SUBJECT: Abraham Lincoln Capital Airport
Springfield, Illinois
Sangamon County
Illinois Project Number: SPI-4635
SBG Project Number:
Contract No. CA020
Item No. 4A, April 27, 2018 Letting
Addendum A

NOTICE TO PROSPECTIVE BIDDERS

Addition of Power Duct Bank and Handholes to the electrical plans.

USER NAME = jcowley	DESIGNED	REVISED A 4/23/2018	STATE OF ILLINOIS DEPARTMENT OF TRANSPORTATION	ELECTRICAL PLAN - SHEET 1		TOTAL SHEETS	SHEET NO.
		DRAWN	REVISED -				75	56
		CHECKED	REVISED -				IL. PROJ. SPI-4635	DRAWING E-1
		DATE	REVISED -					
PLOT DATE = 4/23/2018

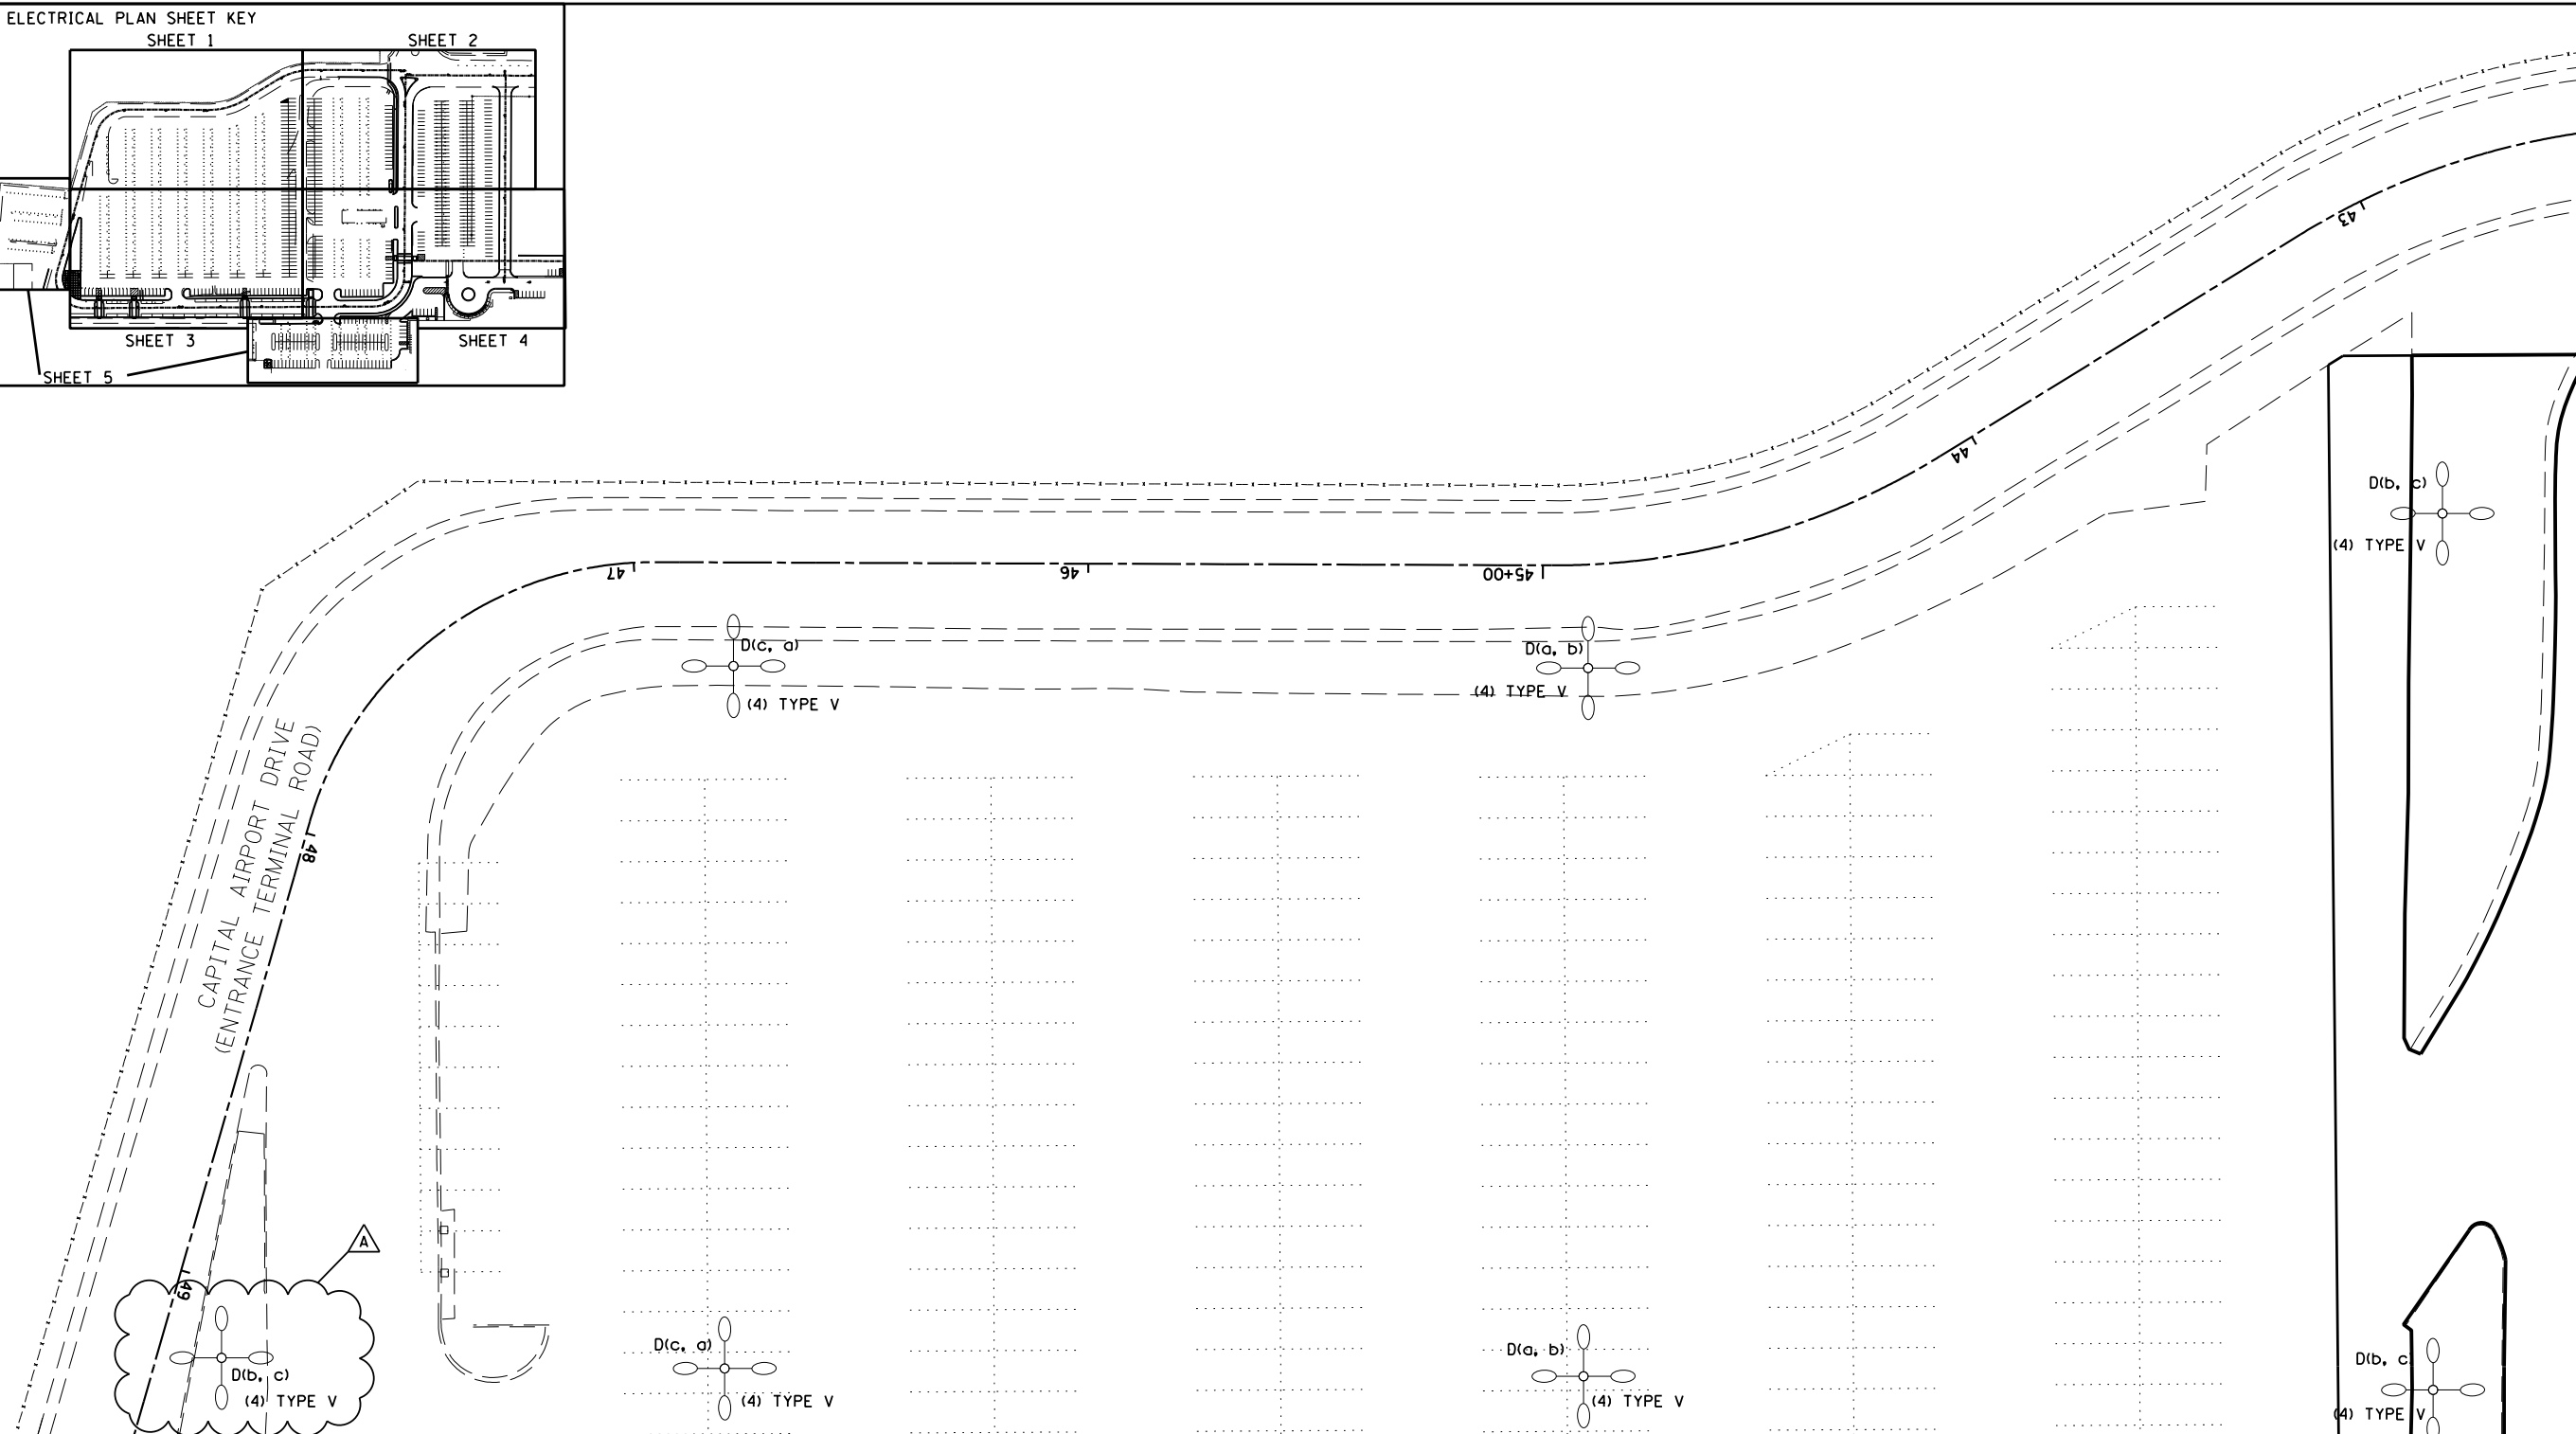
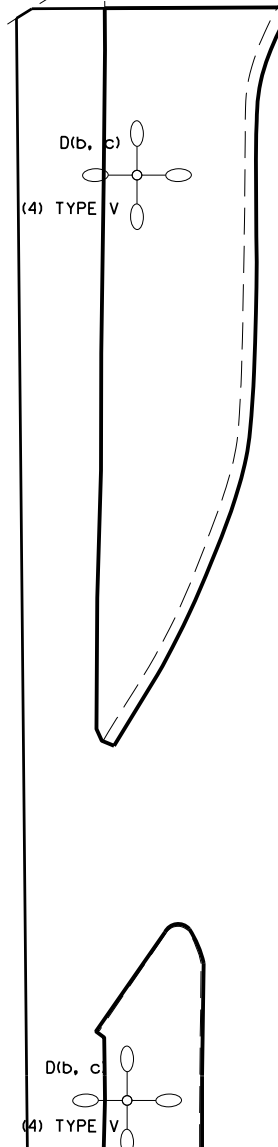
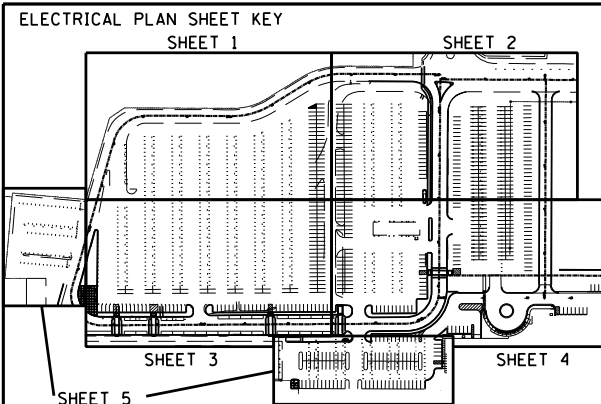
8. Plan Sheet 56-Show fourth luminaire to remain and deleted key note 1.
9. Plan Sheet 57-Show fourth luminaire to remain and deleted key note 1. Revised all other key note numbers and revised corresponding callouts on the plan sheet.

A NOTE REMOVED

TOTAL SHEETS	SHEET NO.
75	59
IL. PROJ. SPI-4635	DRAWING E-3

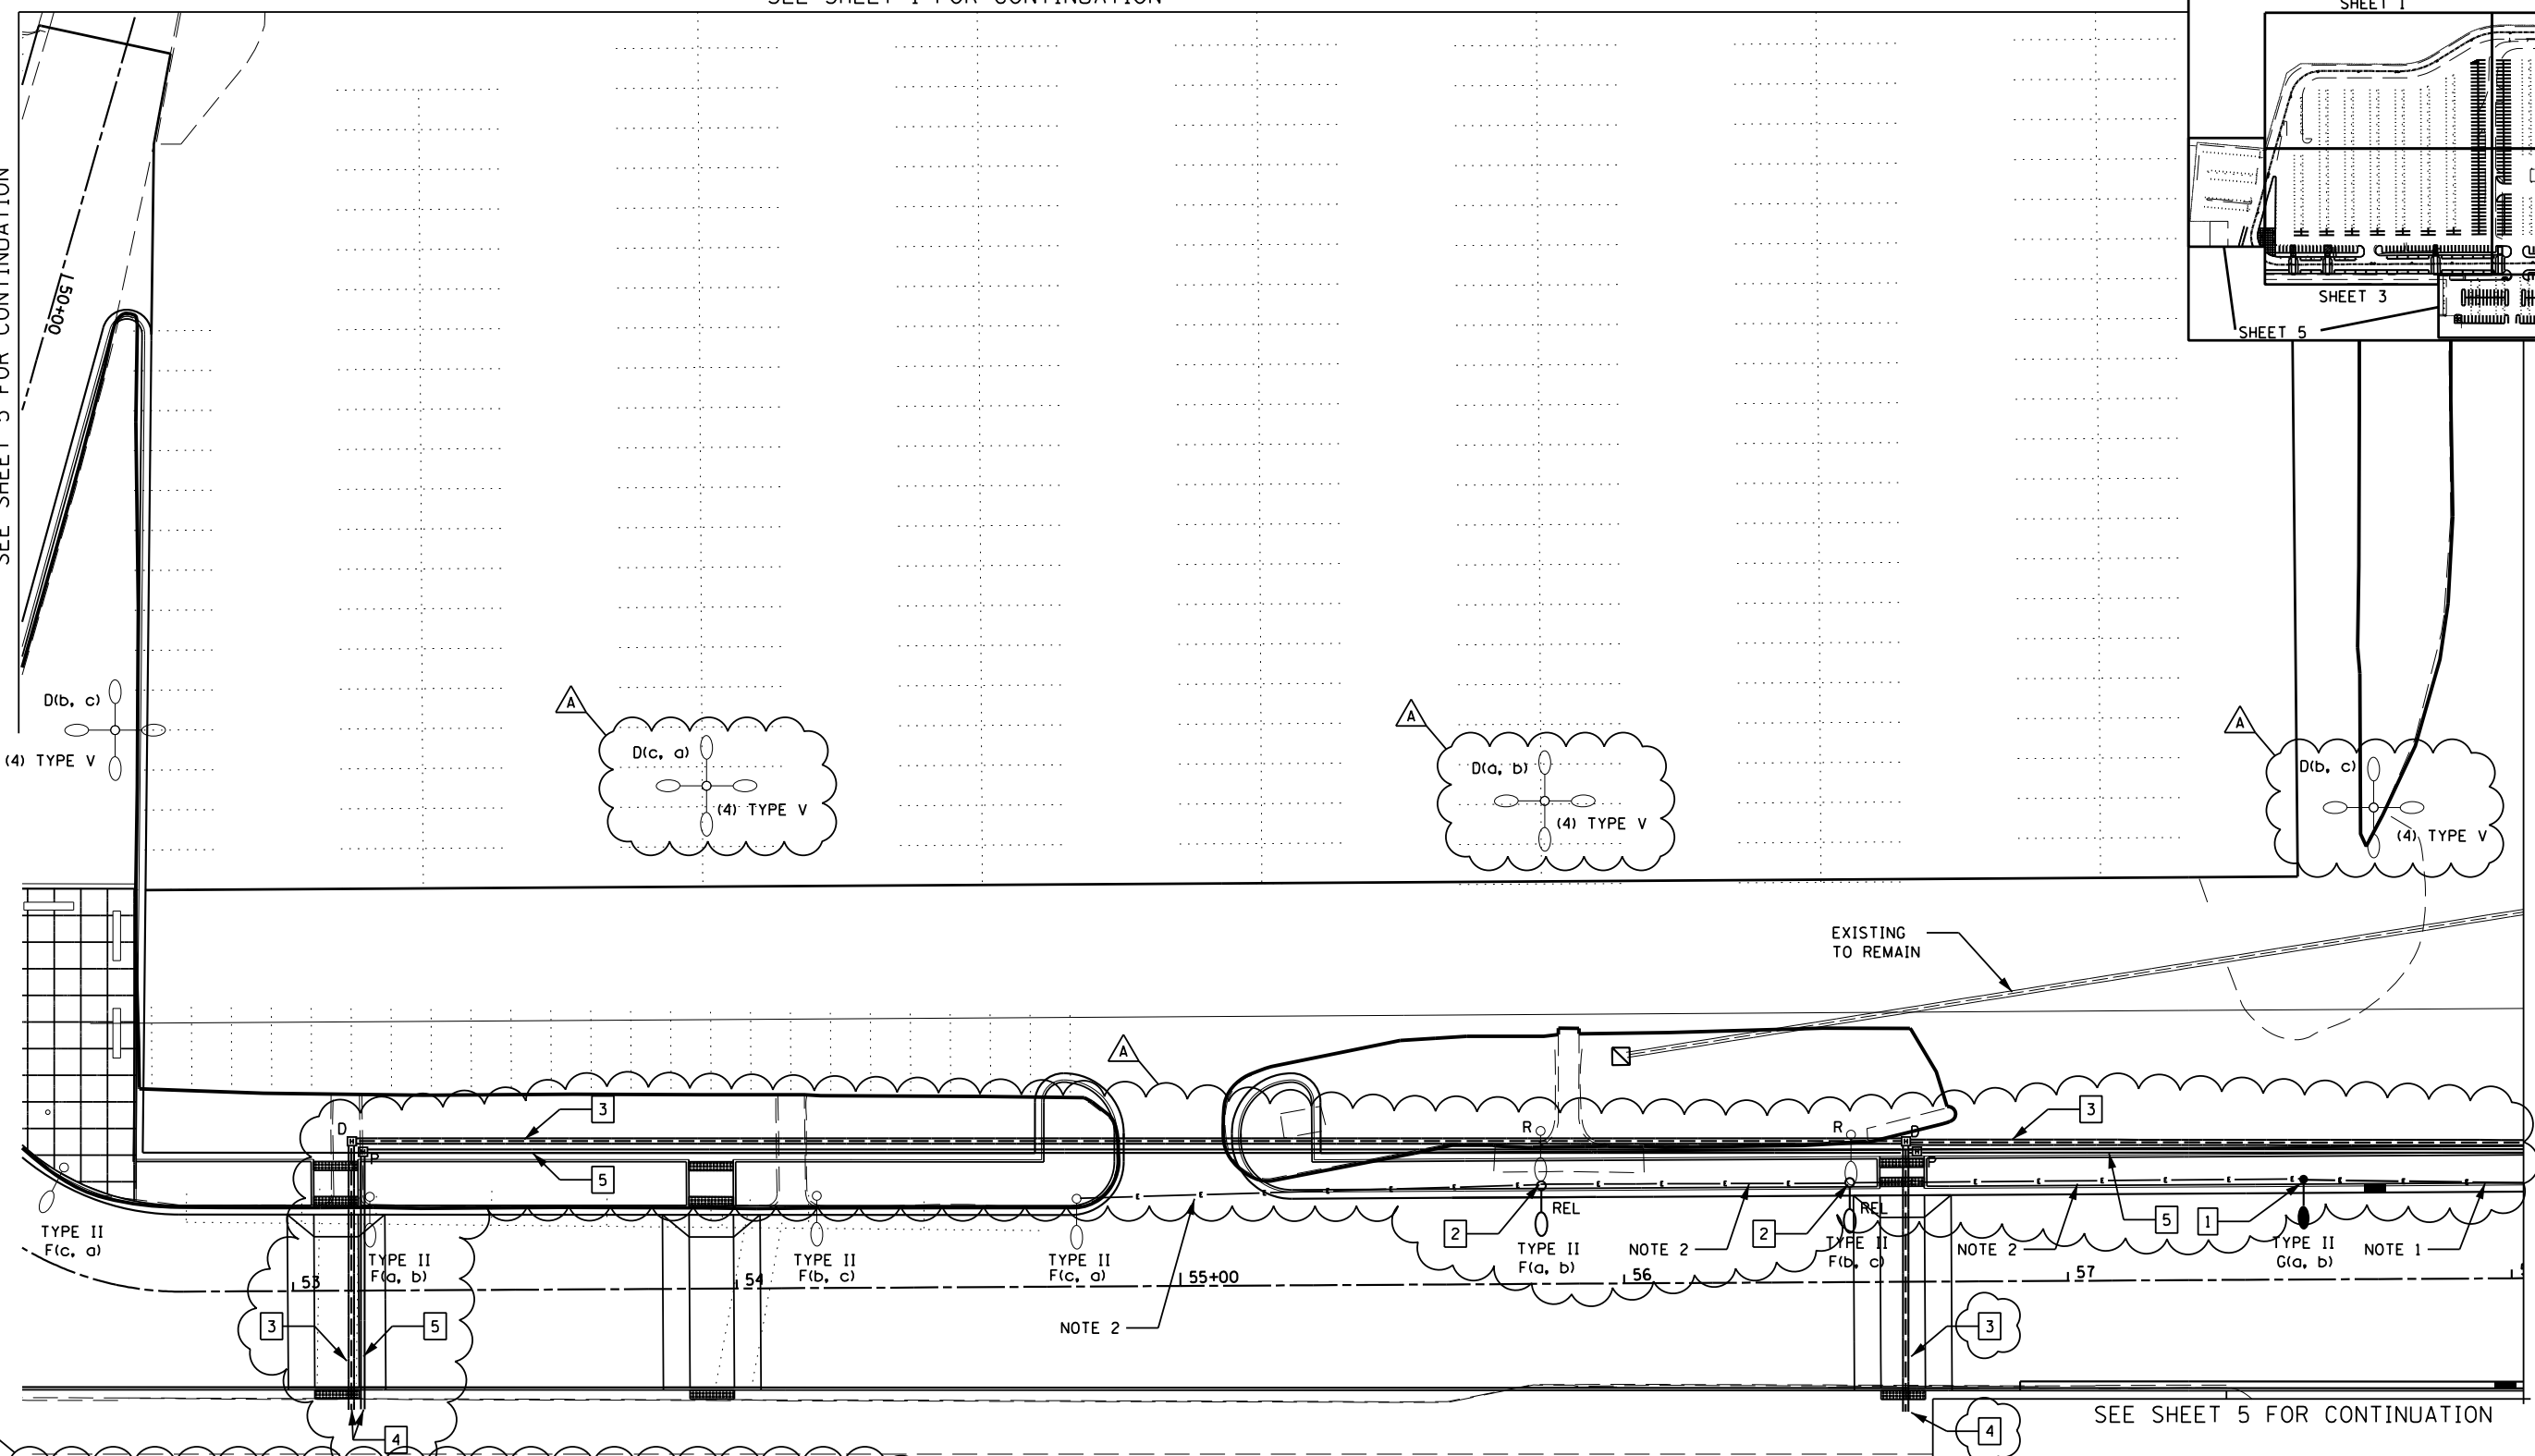
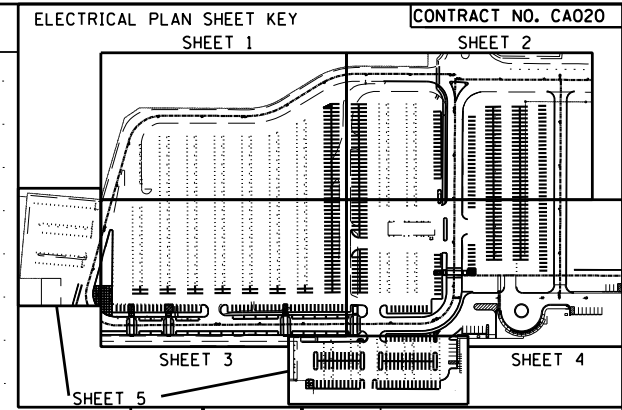
10. Plan Sheet 59-Added proposed power duct bank plan, handholes and notes.
Show fourth luminaire to remain and deleted key note 1. Revised all other key note numbers and revised corresponding callouts on the plan sheet.

- 1 PROVIDE LIGHT POLE AND FOUNDATION PER DETAILS 1 AND 3 ON DRAWING E-7. PROVIDE LED FIXTURE PER GENERAL NOTES ON DRAWING E-0.
- 2 PROVIDE FOUNDATION PER DETAIL 3 ON DRAWING E-7. PROVIDE LED FIXTURE PER GENERAL NOTES ON DRAWING E-0.
- 3 PROPOSED DATA DUCTBANK 6-2" PVC CONDUIT ENCASED IN CONCRETE
- 4 CONDUIT TO BE CAPPED FOR FUTURE USE. CONCRETE ENCASEMENT TO STOP 6" BEHIND CONDUIT END.
- 5 PROPOSED POWER DUCTBANK 4-4" PVC CONDUIT ENCASED IN CONCRETE
